CITY OF FISHERS AGENDA

BOARD/COMMISSION: Planned Unit Development (PUD) Committee

**Planned Unit Development (PUD)
Committee Staff Report**
Meeting Date: October 1, 2025

CASE NUMBER:
PUD-25-10

Proposed Elevations

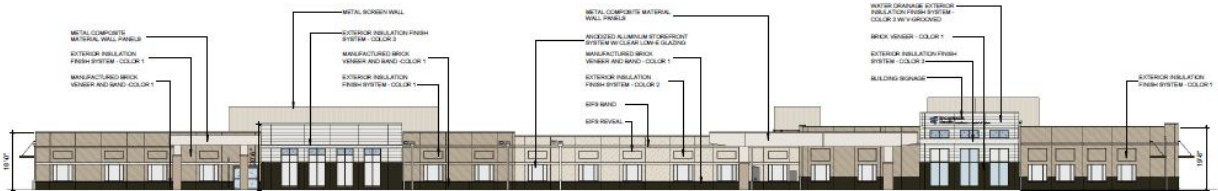
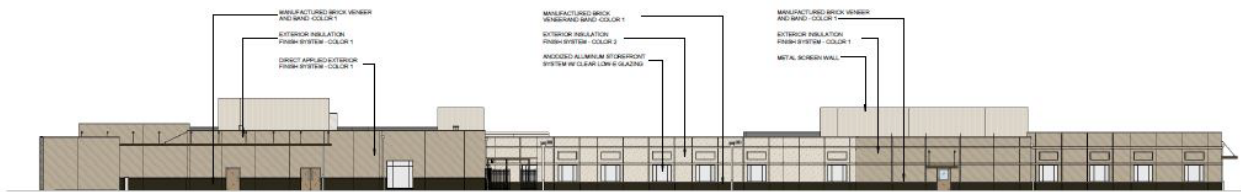
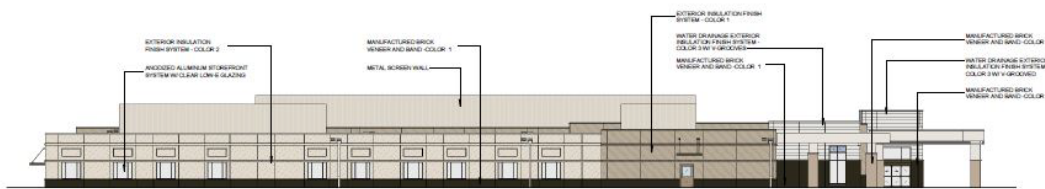
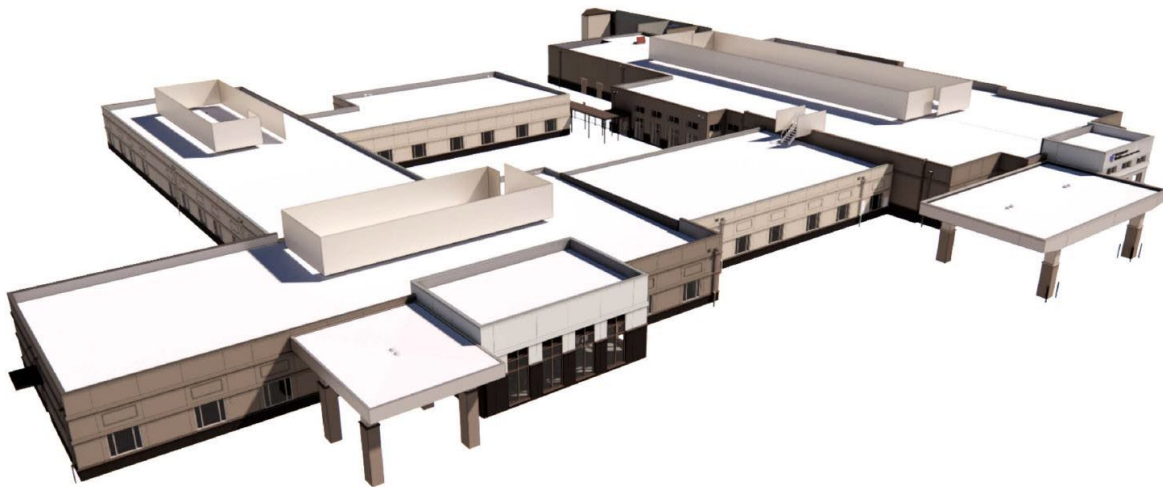
The MedTech PUD does contain architectural standards. Staff reviewed the elevations according to UDO Section 6.3.5. Standards that are met are identified with an “X”.

The roofline standards are not met to the letter, but Staff believes that the spirit of the regulation are met.

The petitioner has met staff requests for HVAC screening, roof access, ladder screening.

Staff recommends approval on the condition that all TAC comments are addressed before final approval is given.

ELEVATIONS

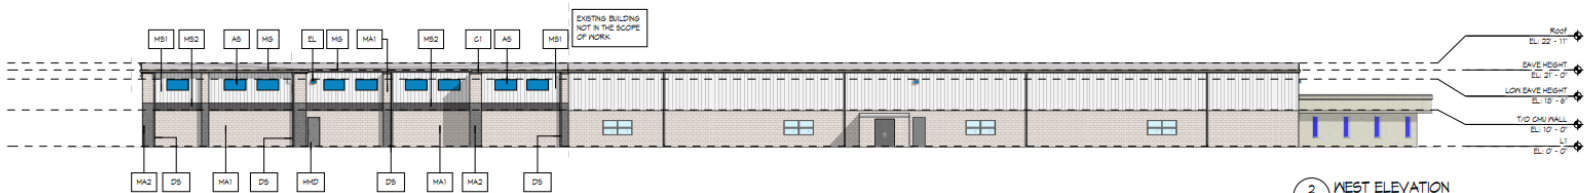
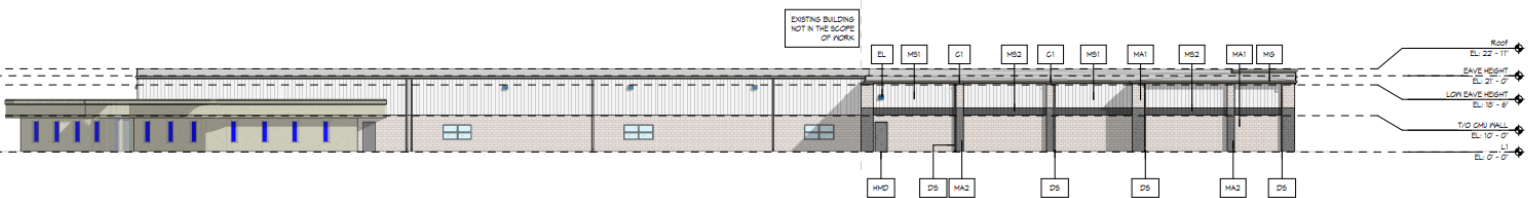
The Fairlane Center and Kirkpatrick PUD does not contain architectural standards. Staff reviewed the elevations according to UDO Section 6.3.5., for industrial buildings. Standards that are met are identified with an “X”.

The roofline standards are not met to the letter, but Staff believes the form of the roofline mirrors the existing warehouse roofline and adds some interest within the modulation areas.

X	For at least 30% of applicable facades, use any combination of concrete, masonry, stone, or unique variation of color, texture, or material, at least 10” in height, around the base of the building. May alternatively incorporate other architectural features such as ledges, façade reveals, ground level fenestration, raised planters, or landscaping elements within 3’ of finished grade.
X	Where building designs incorporate multiple stories, or multiple floor height equivalents, integrate at least one (1) field or accent color, material, or architectural feature used on lower stories, on the upper stories.
N/A	Building designs with multiple stories must provide proportionally taller ground-level façades adjacent to public roadways and public spaces. Provide a floor-to-ceiling height, or floor-to-floor height of 10’ to 16’.
X	Incorporate doors and windows for at least 40% of applicable 1 st floor façade, or provide faux window and door treatments that incorporate at least two (2) of the following: material changes, reveals in conjunction with color or material change, qualifying modulation such as recessed areas, architectural trellis, awning and canopies over access areas, detached structures such as pergola, or similar architectural features and details. Big box and buildings in industrial districts may limit applicable façade area to 30’ around public entries. They included upper windows on the warehouse expansion, instead of 1st floor windows as this area is warehouse storage.

Staff recommends approval on the condition that all TAC comments are addressed before final approval is given.

LANDSCAPE PLAN

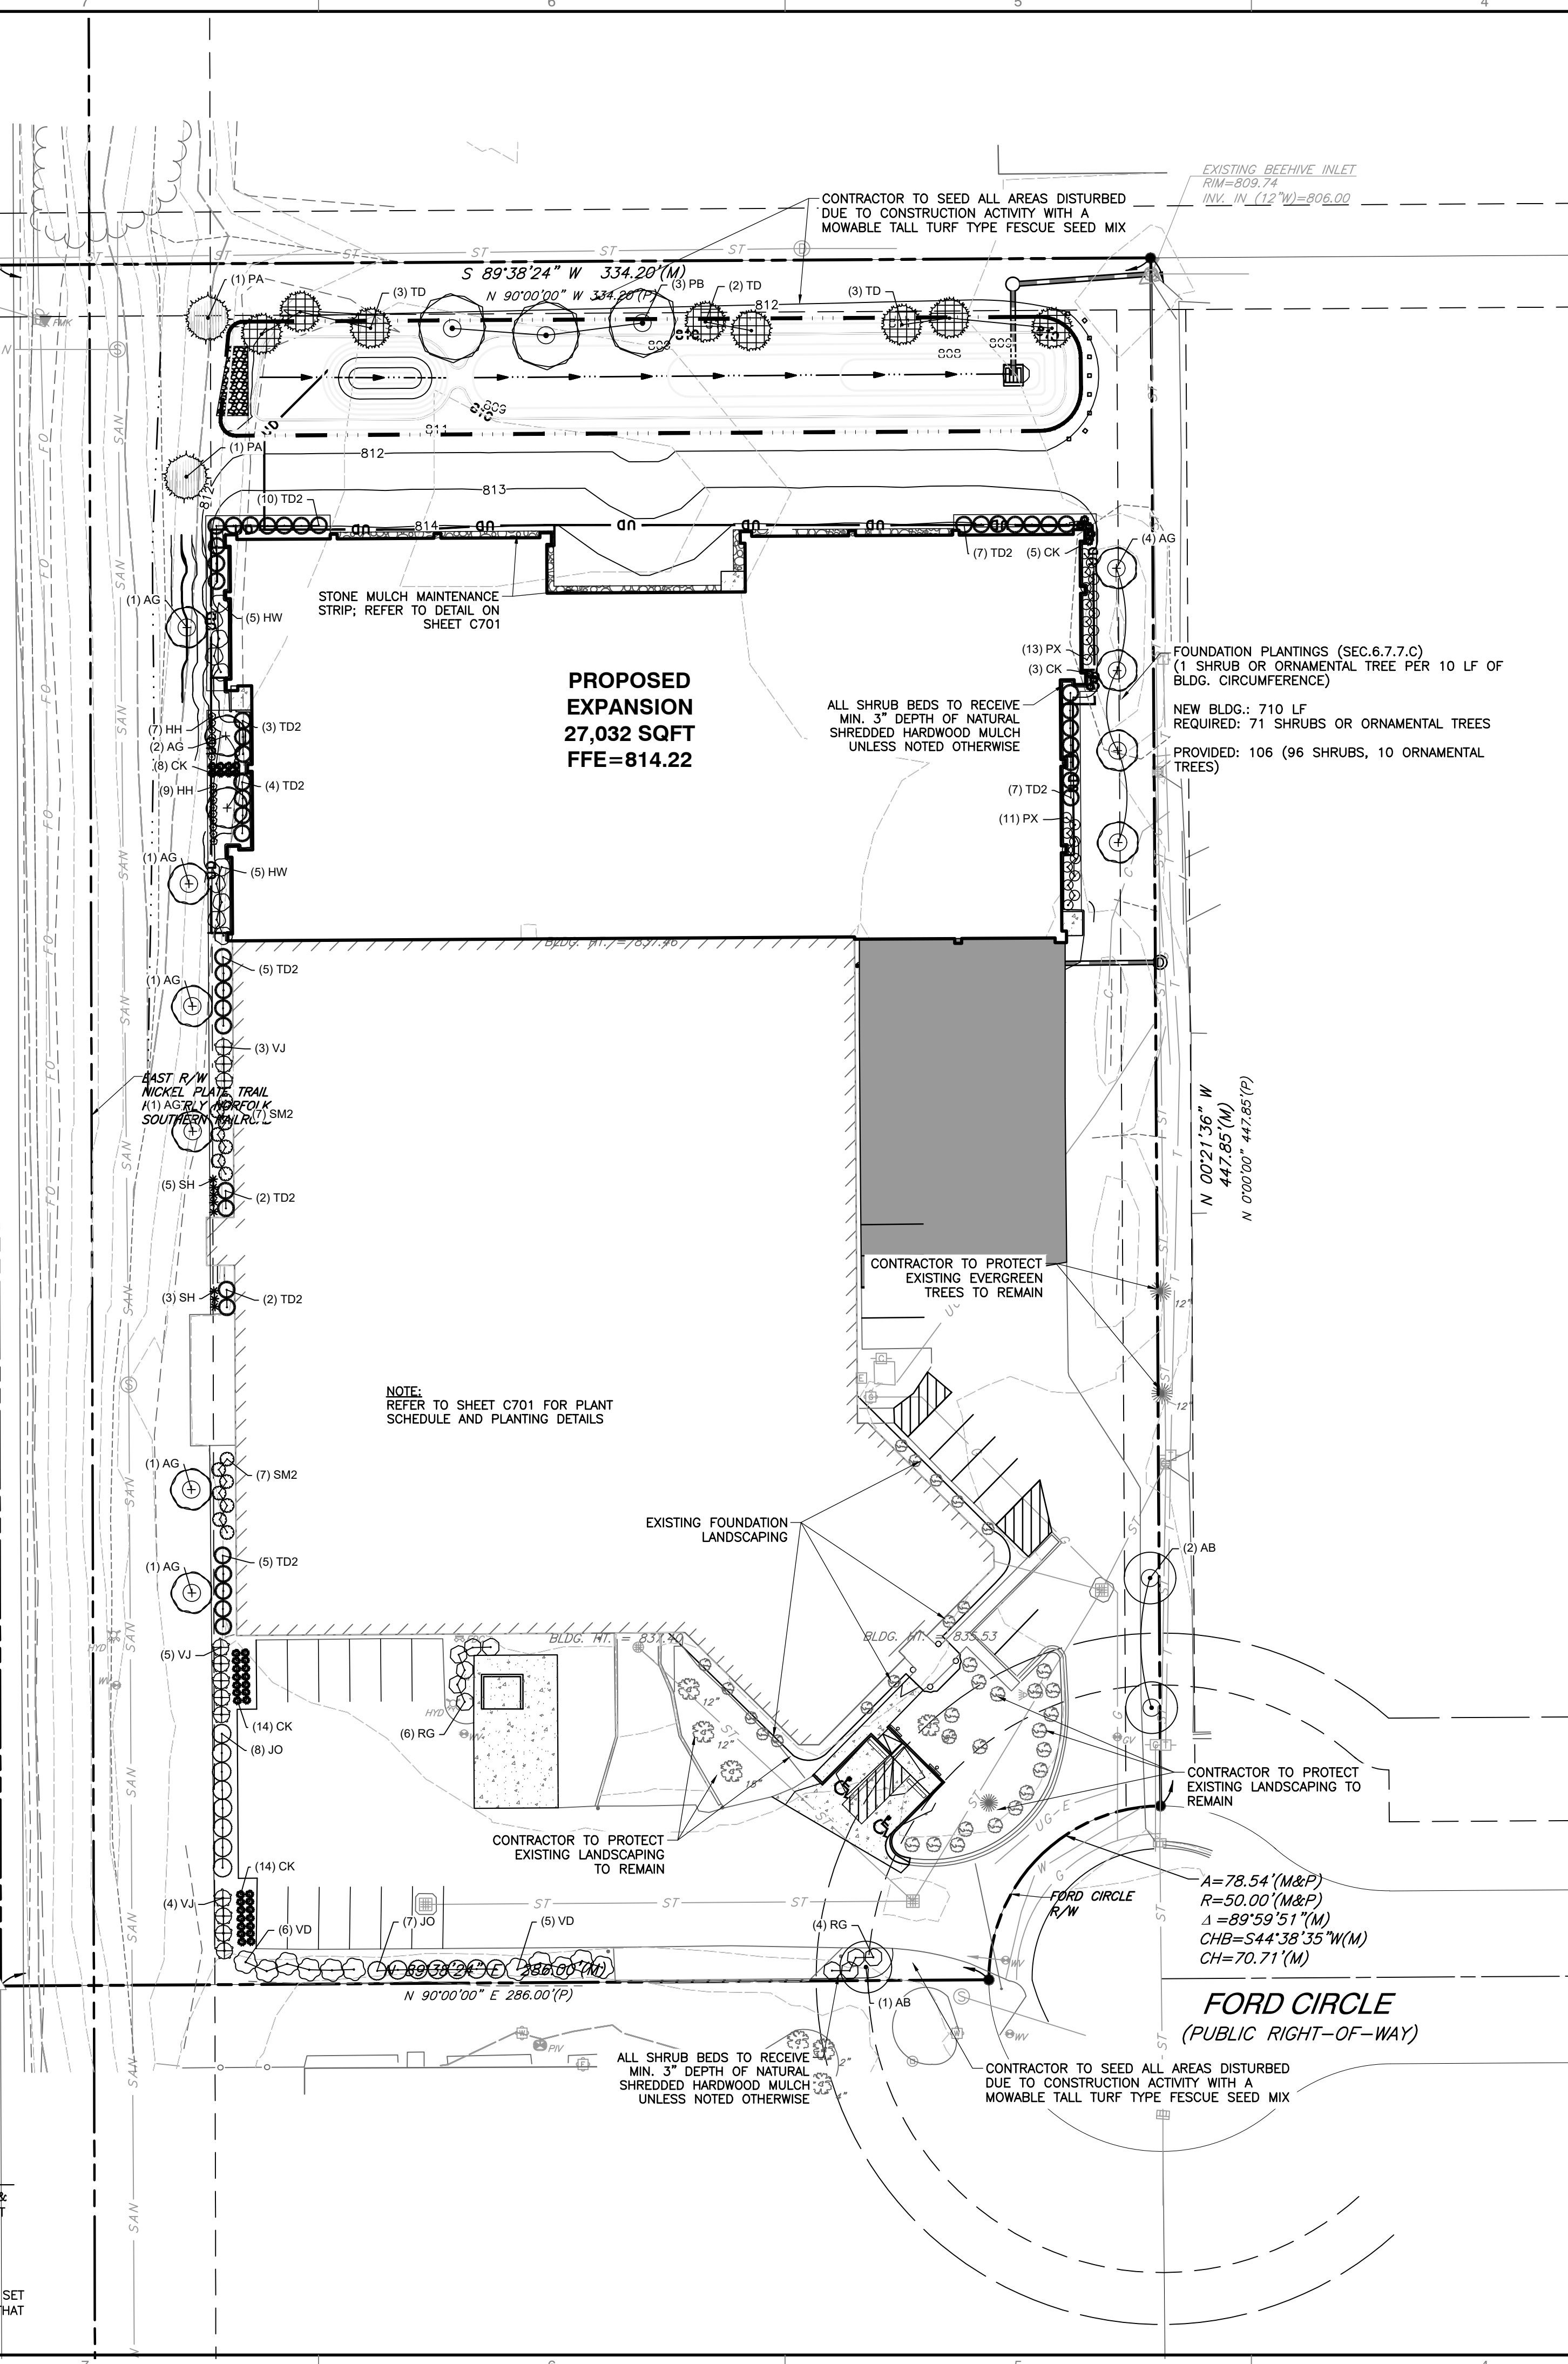
Staff also asked the petitioner to bring the foundation plantings along the western building elevation up to code. Section 6.7.6.C. of the UDO states at least one (1) shrub and/or ornamental tree shall be planted for every 10 lineal feet of building circumference. Non-residential buildings may exclude the dock openings. *This building is 350 ft long, 35 shrubs/ornamental trees would be required. The petitioner has proposed 52 shrubs and 7 trees along the west elevation, facing the Nickel Plate Trail.*

The petitioner has met staff requests for architecture and landscape improvements.
